September 24, 1981
L-81-420

Re: St. Lucie Unit 2
Docket No. 50-389
Final Safety Analysis Report
Requests For Additional Information

Attachment to L-81-420
September 24, 1981

PLAN
INTAKE AREA COMPACTION PILES

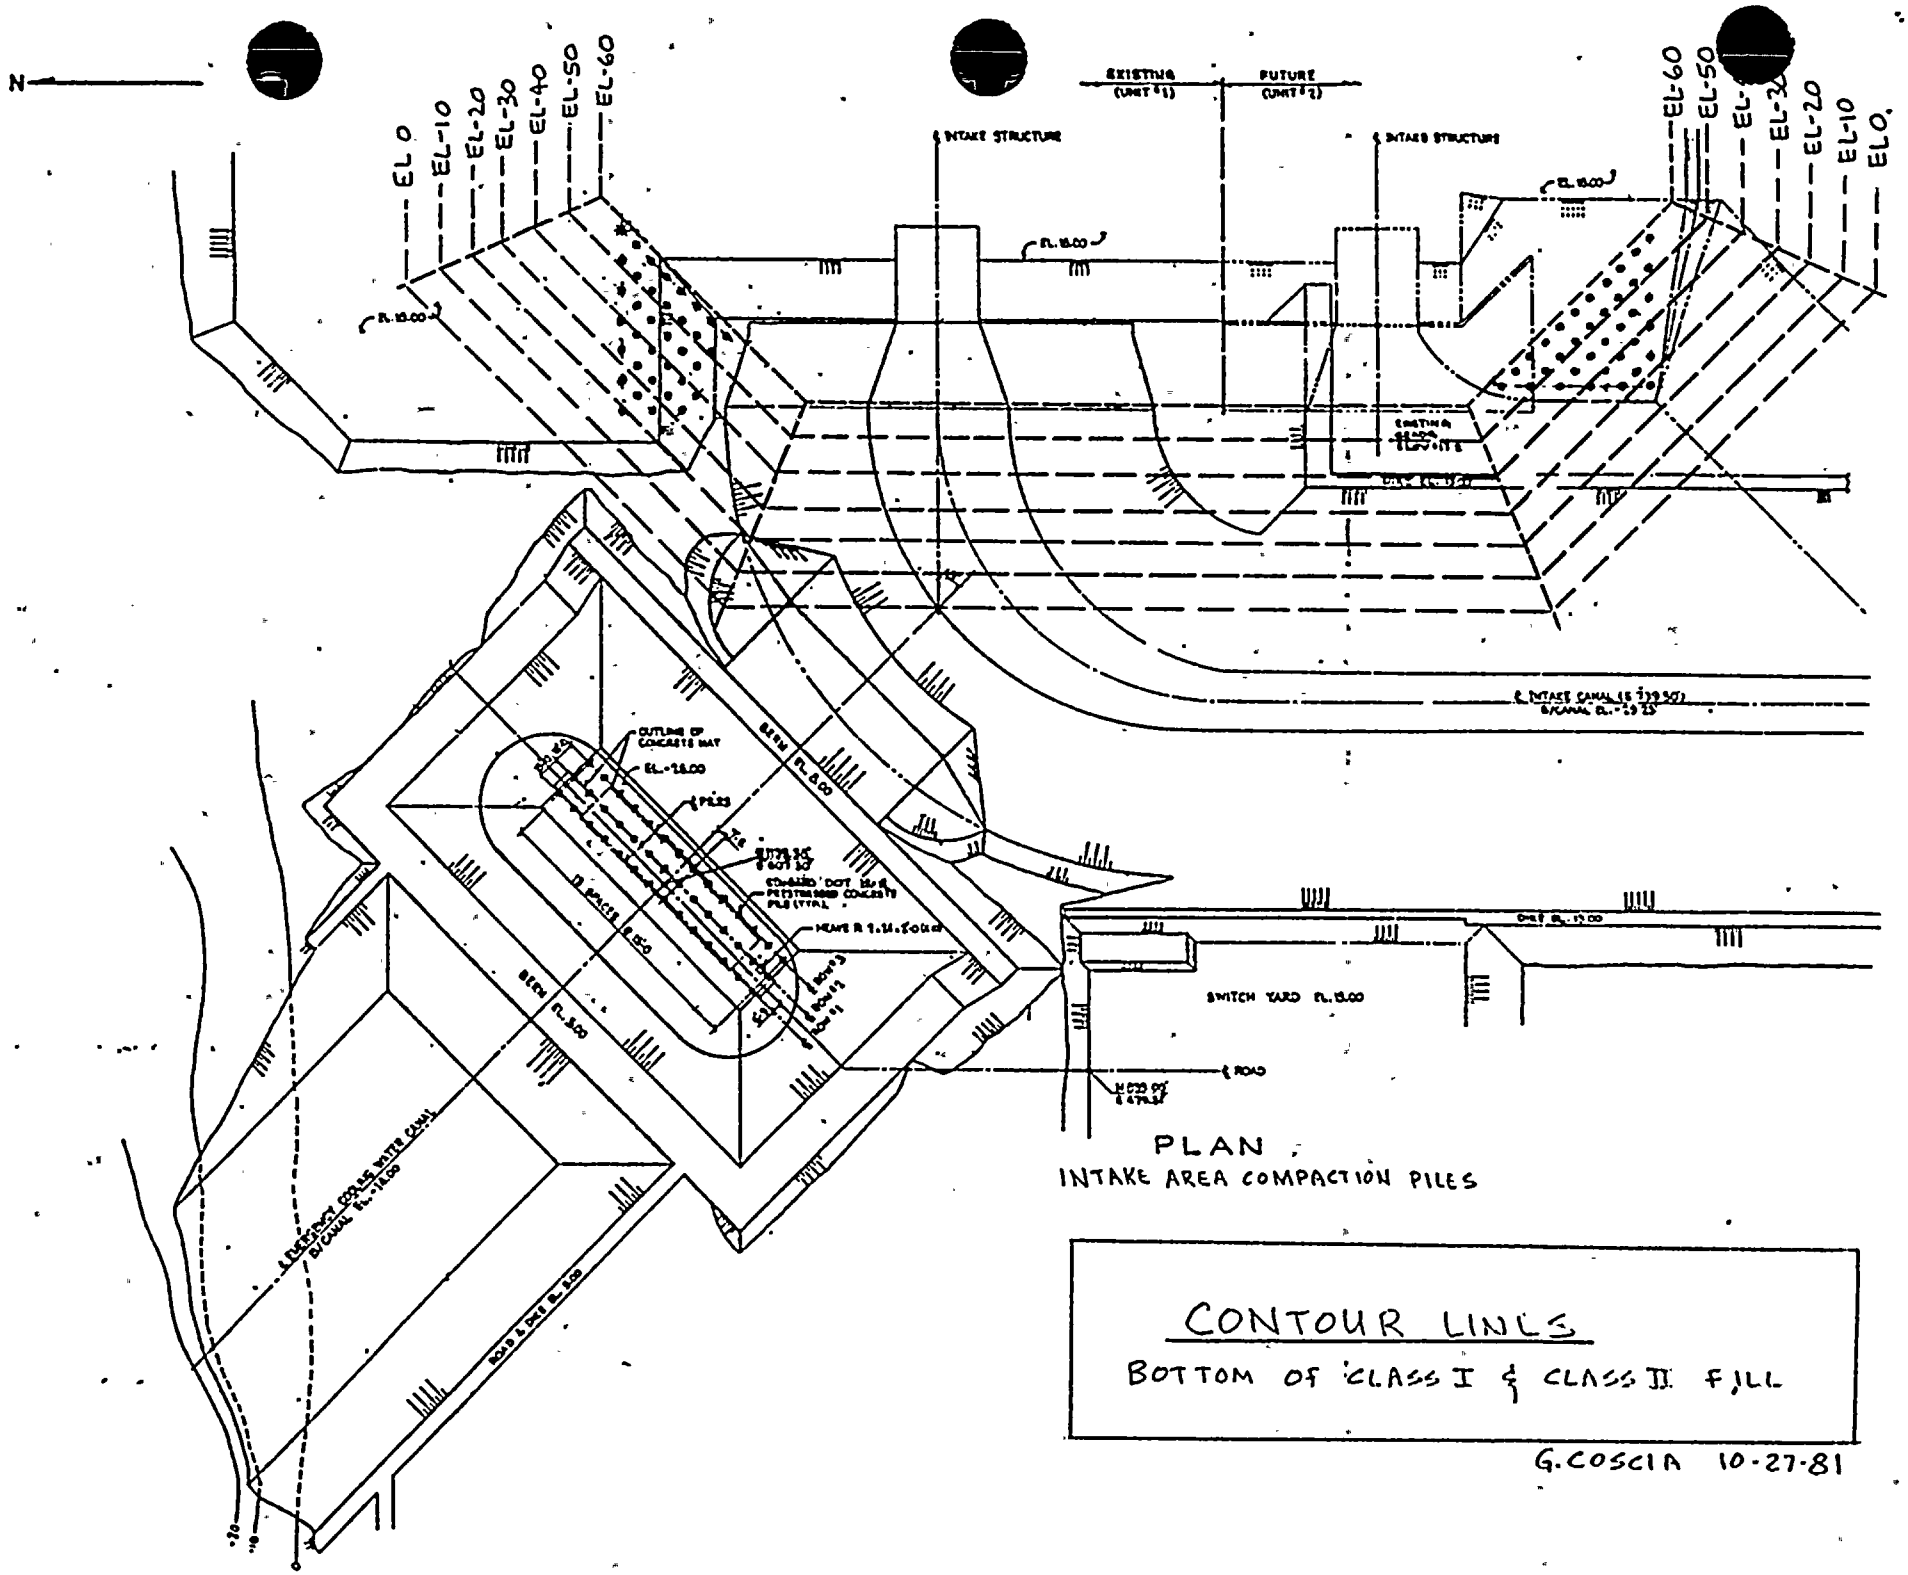
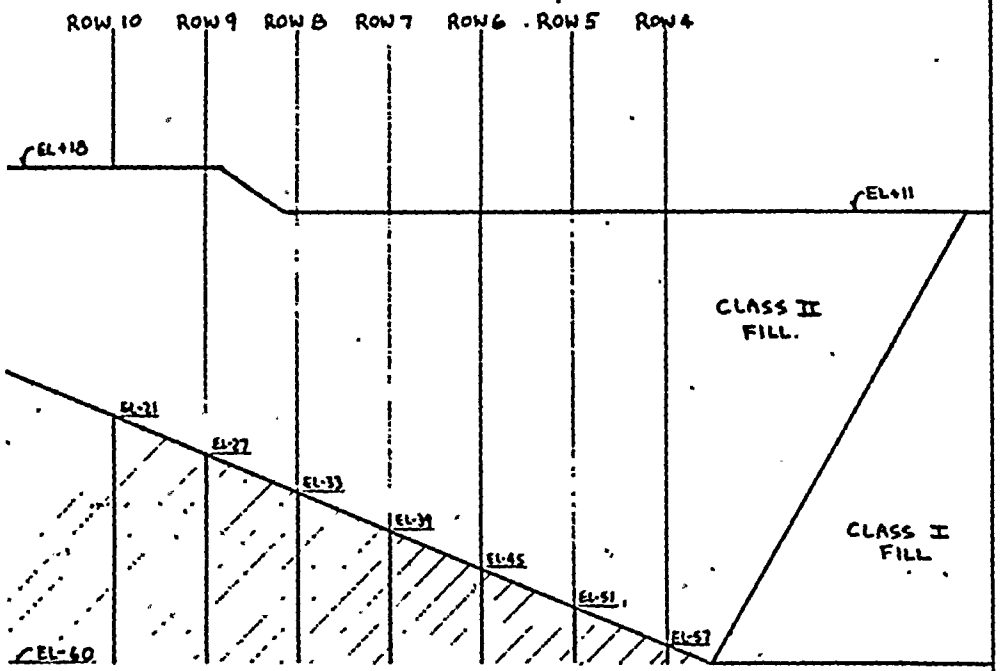
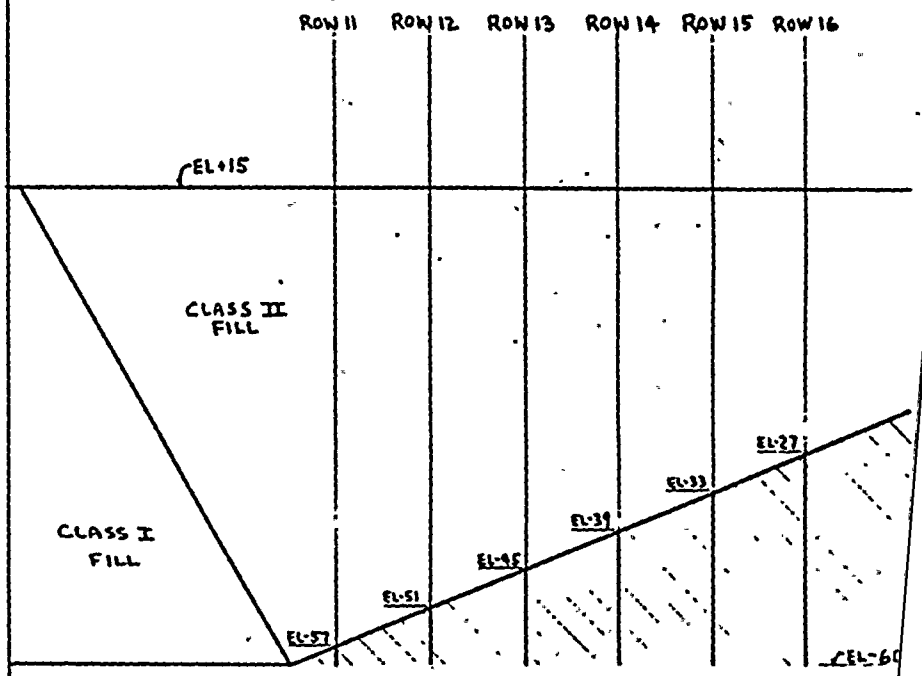
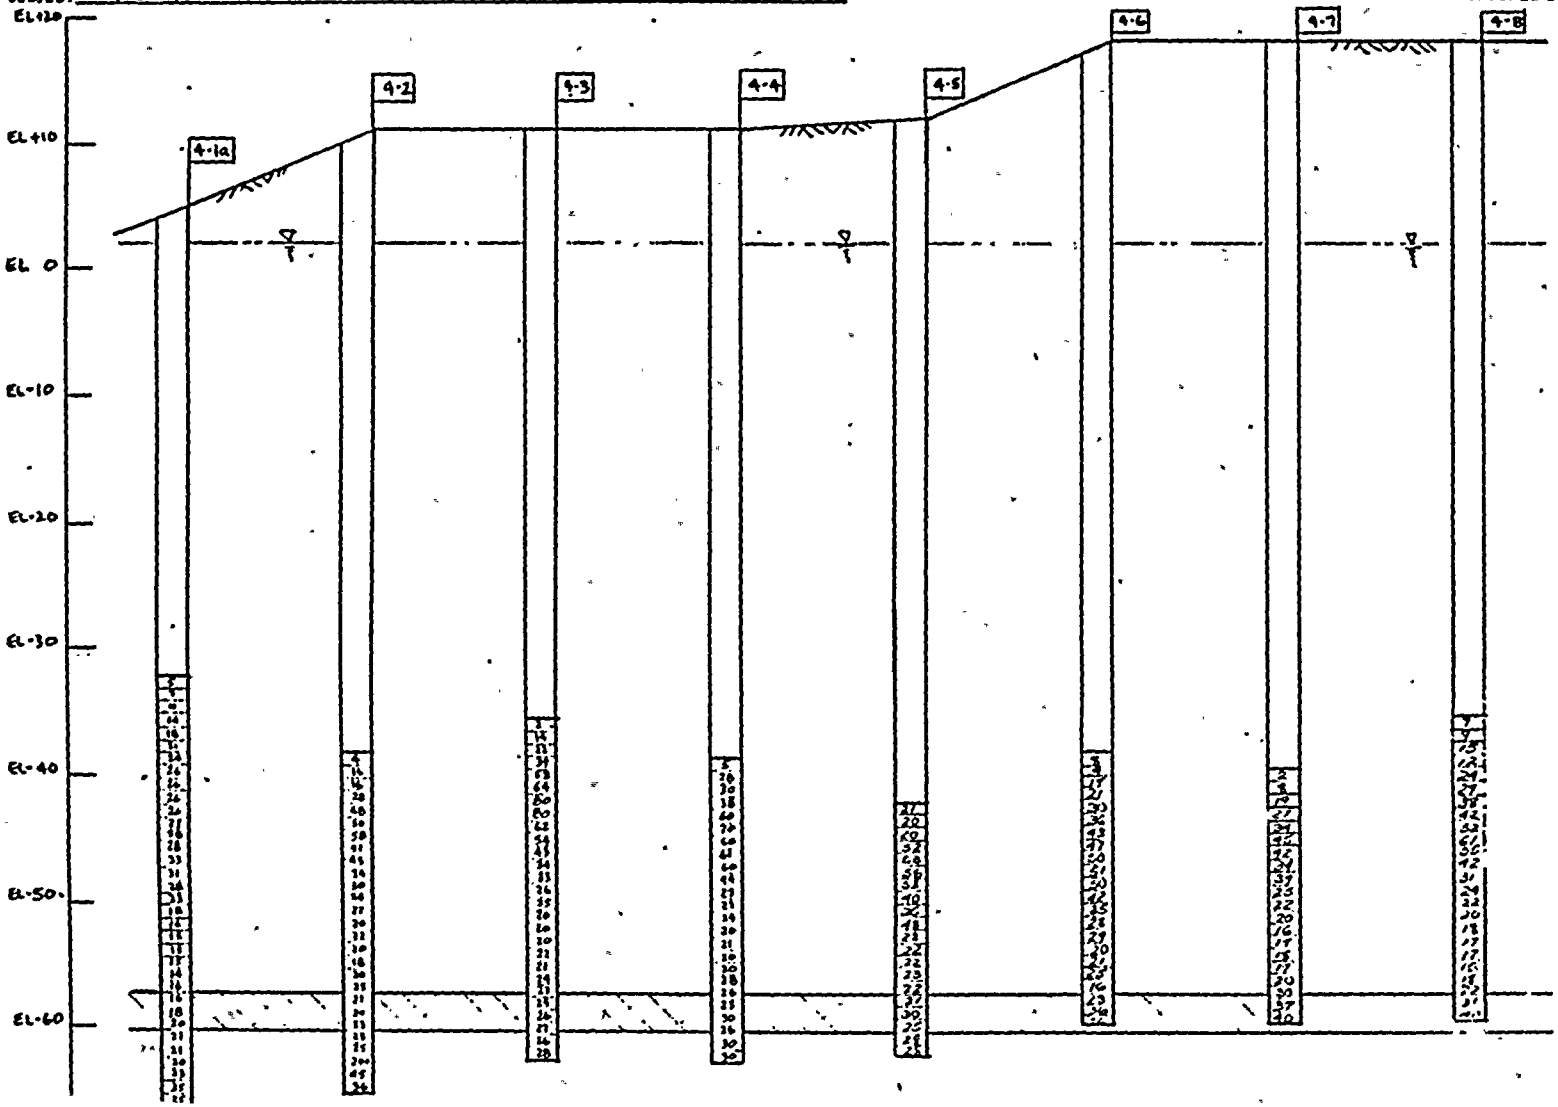
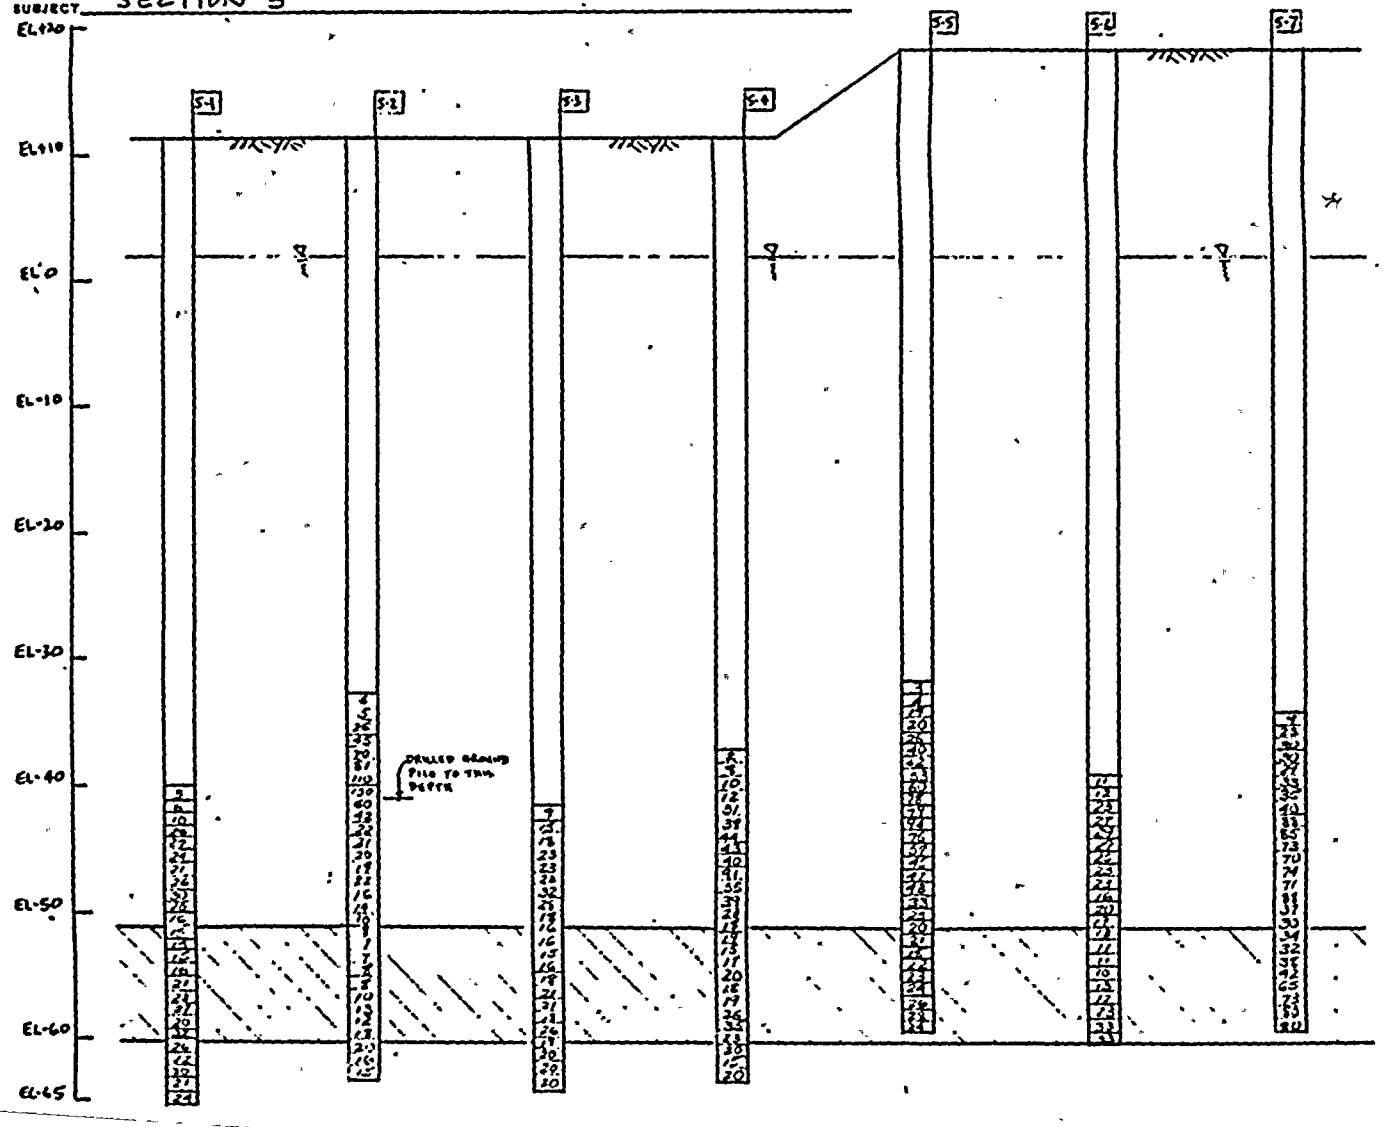
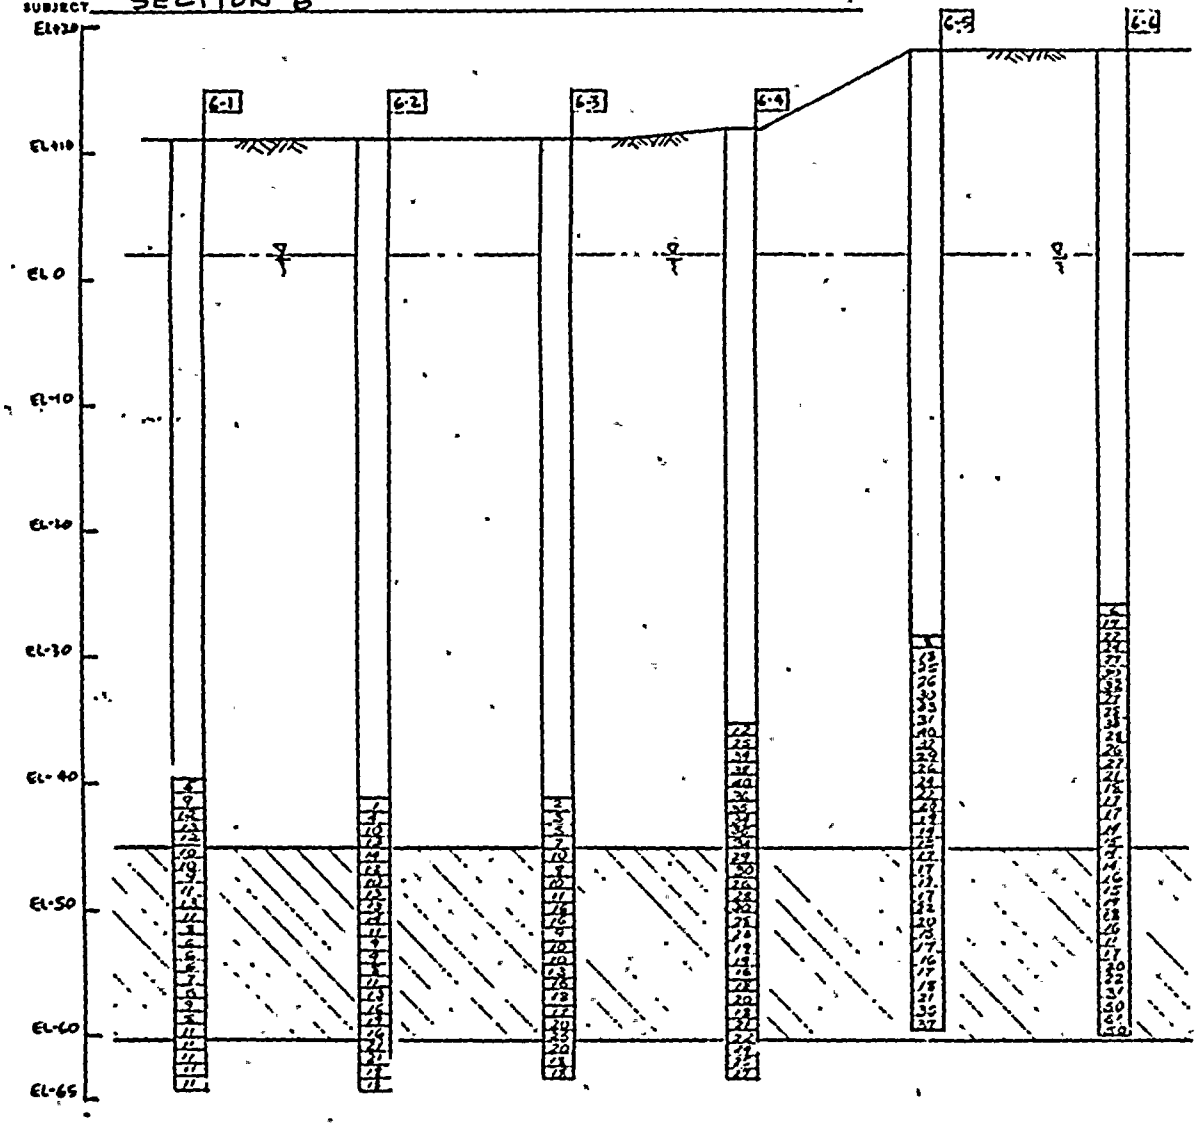
The NRC staff opened the meeting by reviewing their concerns related to a blockage of the plant's circulating water system intake structures by a land slide resulting from the liquefaction of subsurface soils during a seismic event. They noted that their concerns were still valid since it appeared that there was still a layer of in-situ soils that had not been densified by the compaction piles placed in the slopes north and south of the intake structures (see minutes for meeting of October 14, 1981).

The NRC noted that, based on the information presented, the compaction piles in the north and south slopes would be acceptable. They added that several items would have to be included in a docketed submittal:

5. An explanation as to why other piles hung up above the interface should be provided.

Ebasco agreed to revise the submittal to incorporate the above items by Wednesday, October 28, 1981.

2) The attached 14 figures present a plan of compaction pile locations and a cross section through the different rows of piles. The cross sections show the Class II fill and insitu soil interface as well as the depth the piles settled to and the driving records per foot of pile. As shown on these cross sections, the piles were driven through the insitu material as required. In fact, in most cases, the pile blow counts are very high. Based on these profiles and the length of pile that was driven, we are convinced that the insitu soils were densified by displacement and compaction.

FIGURE 1

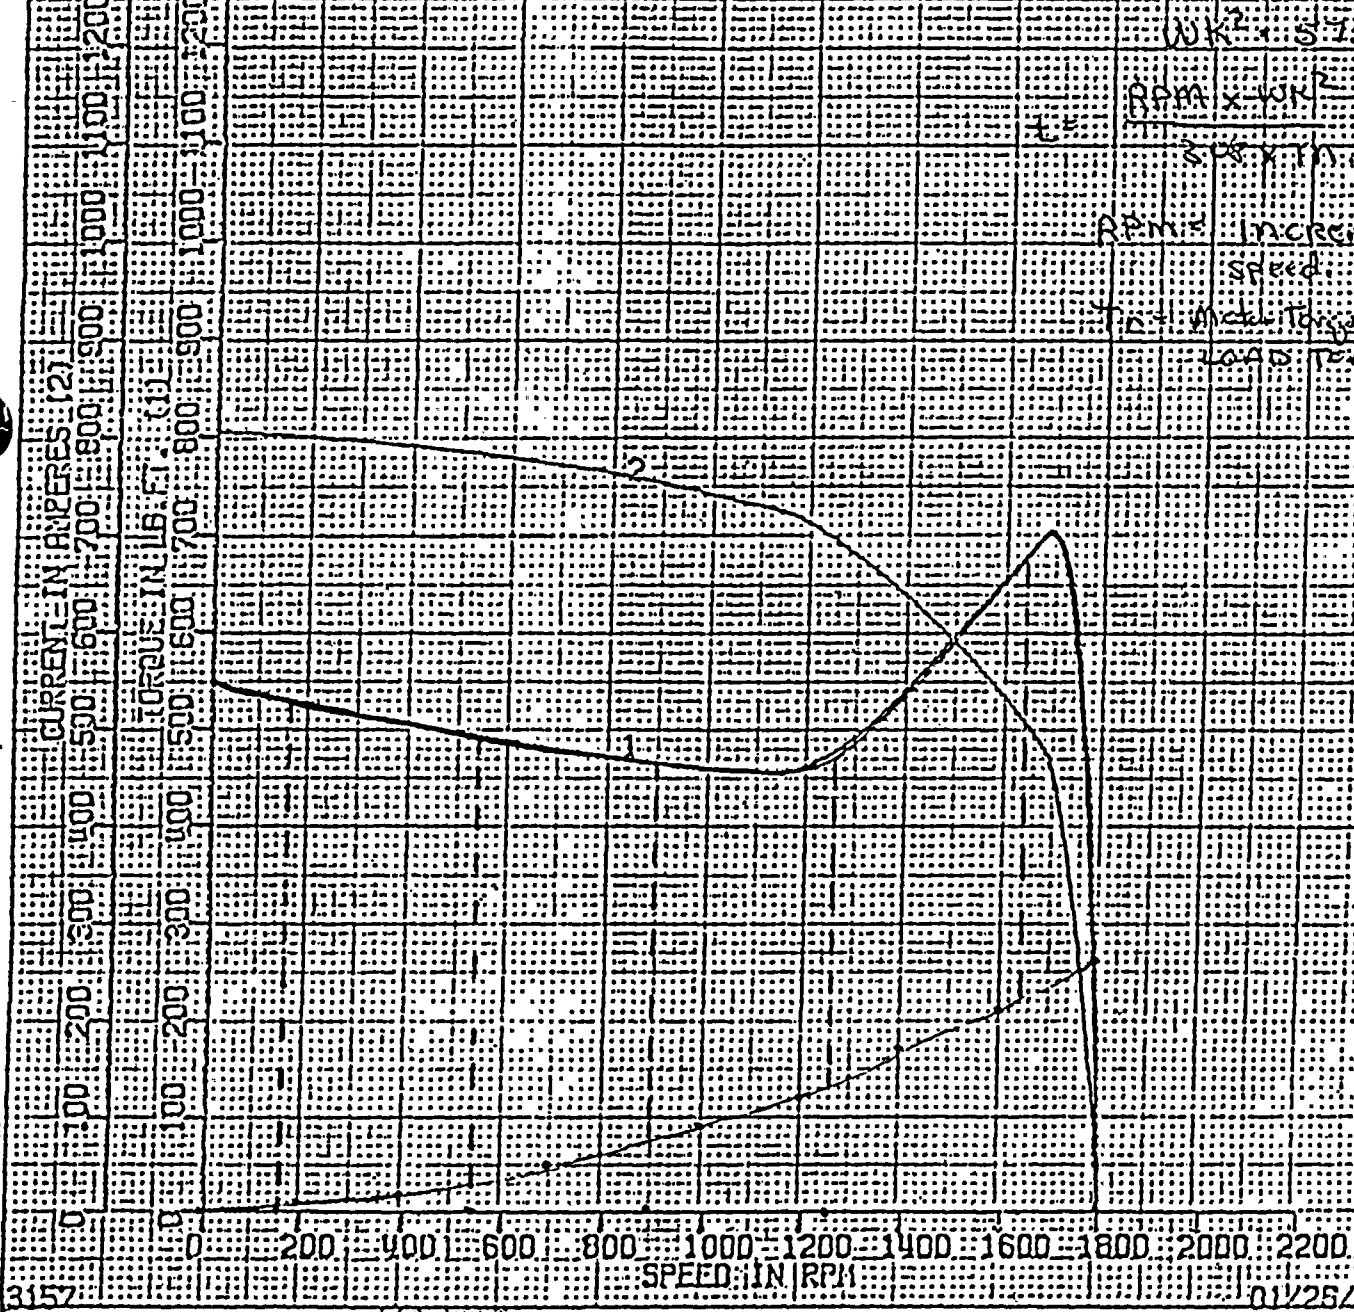
To assure that the motor has sufficient torque to accelerate the driven equipment under this type of transient, the motor manufacturer supplied speed torque curves for motor acceleration considering a constant motor terminal voltage of 80% which is bounding to the starting transient described above. This curve is shown in Figure 1. From this curve net torque (motor torque minus loading torque) was determined at 20% speed intervals and the acceleration time of the motor was calculated to be 7.6 seconds. Comparing this acceleration time to the acceleration time measured in the accident analysis, 10 seconds, indicates that the motor is accelerated in sufficient time as to not impact the accident analysis. To assure that the motors are not damaged during this starting transient, the motor acceleration time was compared to the safe stall time of the motor. From manufacturer's data applied, the safe stall time at 100% starting voltage is 11 secs. (hotstart). The acceleration time of 7.6 secs. is less than 11 seconds and therefore motor damage will not occur. It must be noted that the safe stall time of a motor increases as a result of lower starting voltage since the inrush current is less. Therefore, by comparing the acceleration time at the lower voltage (7.6 seconds) to the safe stall time at the higher voltage (11 seconds) is very conservative. Actual manufacturers data for starting transients such as described above indicates that the safe stall time is increased to 15 seconds.
